# Proposals for Consistency: Figures & Equations

John D'Ambrosia, Force10 Networks  
Pete Anslow, Nortel

# Comment #447

Figure 69B-5—Insertion loss limit for 10GBASE-KR

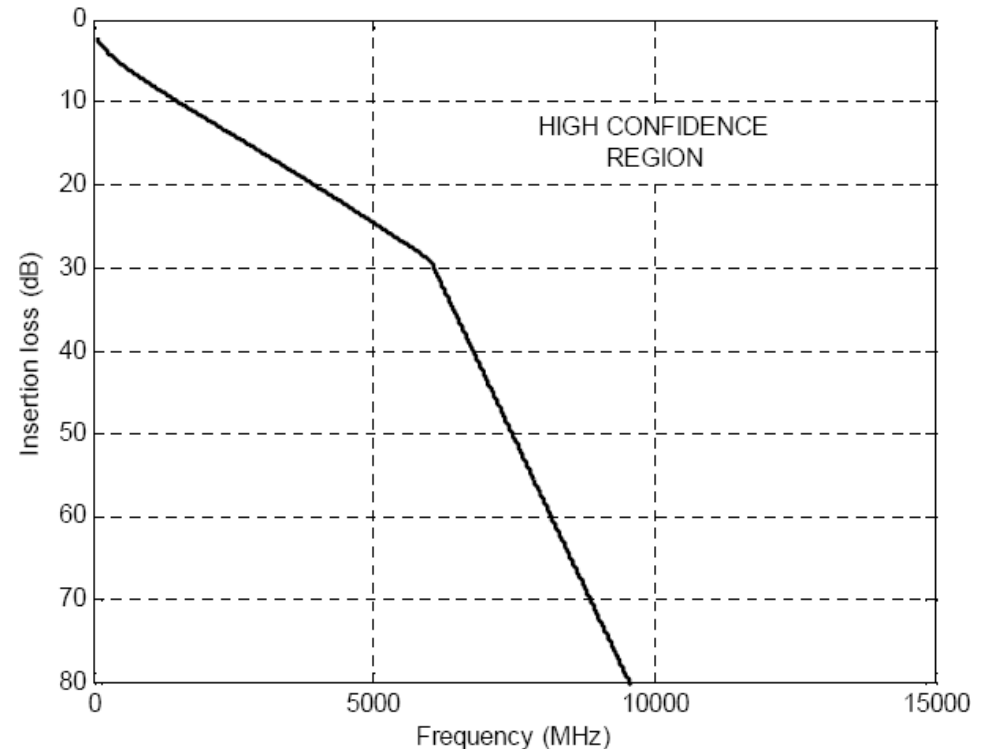
- For X-axis
  - Use linear scale PJA2
  - 0 to 15 GHz
  - Show major gridlines only
  - Axis labels at the bottom
- For Y-axis
  - Minimum value at top of axis
  - Appropriate axis labels along the axis
- Indicate the “Pass” region
- Remember – graphs only illustrate the equation

Do they all need to be the same?

Is linear the best choice? I would have to look at all the plotted equations to be sure.
